Access Compliance Report

Public Rights-of-Way

(Curb Ramps)

Intersection ID: 30255	Main Street: OLD_IRONSIDE_DR	Cross Street: WYLAM_DILLY_CT	Location: E
ADA ID: C3797ACD77DC	Ramp Type: PerpDiag	Initial Pass/Fail: Pass	Overall Compliance: No
Severity Score: 15			
Codes/Mitigation Info/Possible Solution		Field Measurements/Component Compliance

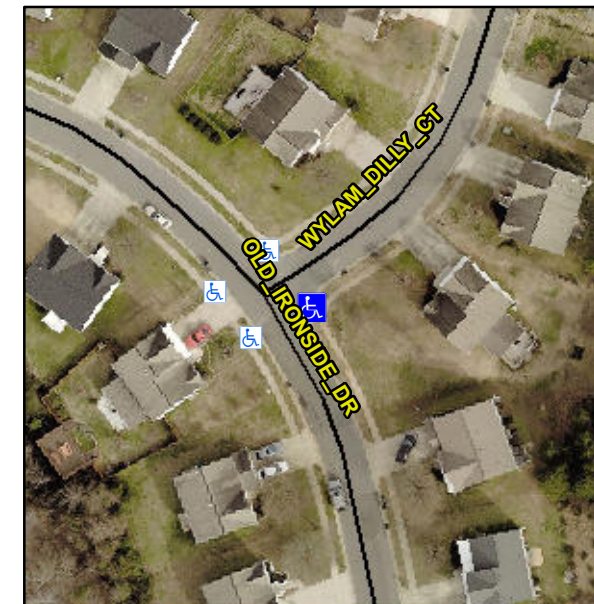
Compliance	Description	Data	Compliance	Description	Data
N/A	Ramp Length (in)	48.0	Yes	Ramp Slope (%)	7.1
Yes	Ramp Width (in)	48.5	Yes	Ramp XSlope (%)	0.3
N/A	Flare Type LT	Sloped	N/A	Flare Type RT	N/A
N/A	Flare Slope LT (%)	5.4	N/A	Flare Slope RT (%)	8.1
N/A	Flare Traversable LT?	No	N/A	Flare Traversable RT?	No
Yes	Landing Length (in)	48.0	No	DWS Provided?	No
No	Landing Width (in)	42.0	N/A	DWS Contrast?	No
No	Landing Slope (%)	5.1	N/A	DWS Length (in)	N/A
Yes	Landing X Slope (%)	1.3	N/A	DWS Full Width?	No
N/A	Landing Curb? (Y/N)	No	N/A	DWS Offset (in)	N/A
N/A	Shared Landing?	No			
Yes	Gutter Ponding?	No	No	Gutter Slope (%)	13.0
Yes	Gutter Lip Ht (in)	0.0	Yes	Gutter X Slope (%)	0.1
N/A	Painted X Walk1?	No	N/A	Painted X Walk2?	No
	X Walk 1 Direction	To NW		X Walk 2 Direction	To SW
N/A	X Walk 1 Width (in)	N/A	N/A	X Walk 2 Width (in)	N/A
	X Walk 1 Slope (%)	2.1		X Walk 2 Slope (%)	0.2
	X Walk 1 X Slope (%)	3.0		X Walk 2 X Slope (%)	0.5

N/A	Ramp inside XWalk1?	N/A	N/A	Ramp inside XWalk2?	N/A
	Road Slope (%)	0.6	N/A	Clear Space?	Yes
	Road X Slope (%)	1.3	N/A	Clear Space to XWalk (in)	N/A
Yes	Any Obstructions?	No	Yes	Storm Grate/Utility Hazard?	No
	Obstruction Type			Storm Grate/Utility Type	
		N/A			N/A
			Yes	Surface Condition? (G/P)	Good

Remove & Replace Curb Ramp With Two New Directional Ramps or Equivalent. Remove & Replace Gutter.
